MEMORANDUM

From:	Service Manager Environment	To:	Head of Community Well-being and Development
Our Ref:	ENV/DC/PP/2016/0023	Your Ref:	KH/P/2016/0023
Date:	19 th January 2016

Location: O. S Grid Ref: 323 506 Briary Close, Croesnewydd Road, Wrexham.

Development: Outline application to erect 9 no. two storey dwellings and construction of new access.

7.5t Panel Van
 Overall Length
 Overall Width
 Overall Body Height
 Min Body Ground Clearance
 Track Width
 Lock to Lock Time
 Kerb to Kerb Turning Radius

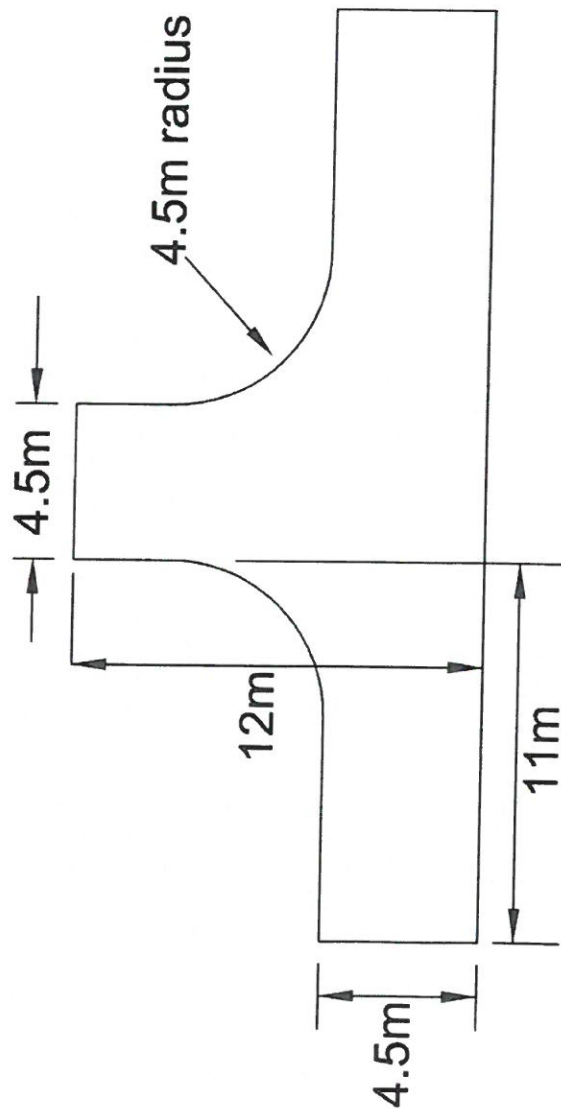
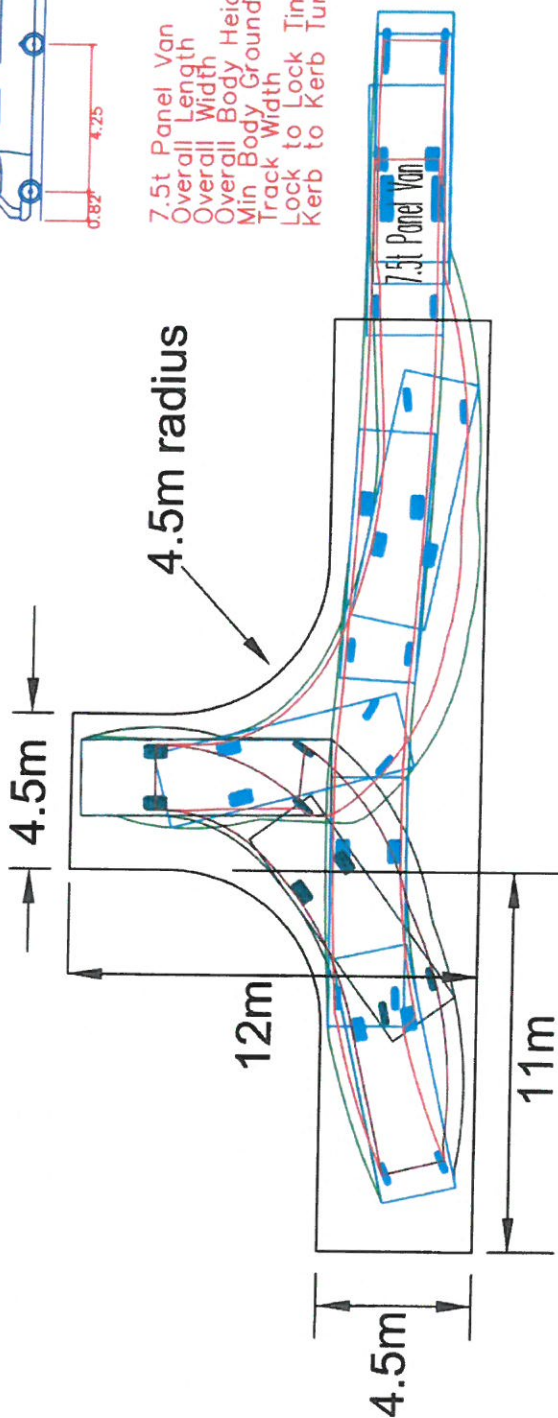
The proposed car parking area has no provision for the turning of medium sized delivery vehicles. **I would recommend that a revised layout plan is provided indicating a suitable turning head within the proposed car parking area (see attached detail).**
